AVR64DB28/32/48/64

Silicon Errata and Data Sheet Clarifications

Figure 34-1. DAC Block Diagram

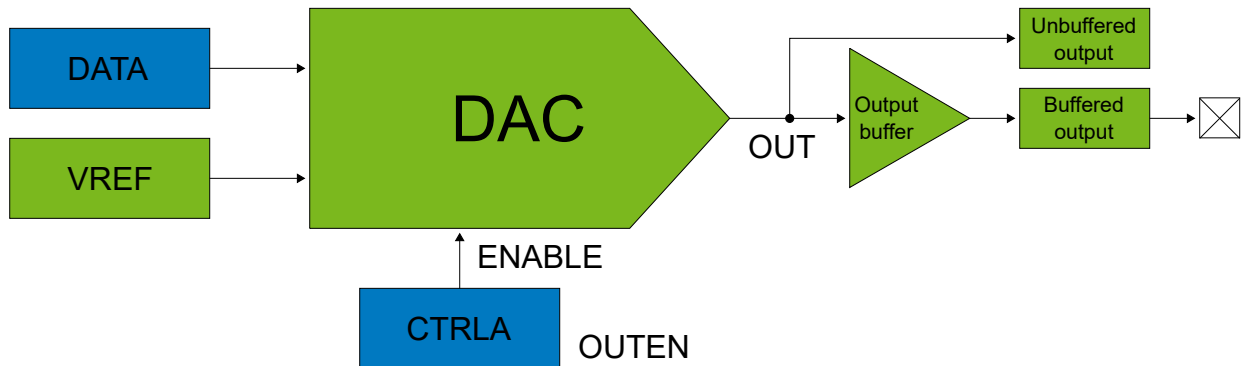
Clarifications of the block diagram and the DAC Output sub-section of the DAC peripheral has been made:

1. The block diagram is updated with clarifications to the output signal routing (buffered/unbuffered) and will replace the original block diagram.
2. Sections 34.3.2.3 (DAC as Source For Internal Peripherals) and 34.3.2.4 (DAC Output on Pin) are replaced by section 34.3.2.3 DAC Output.
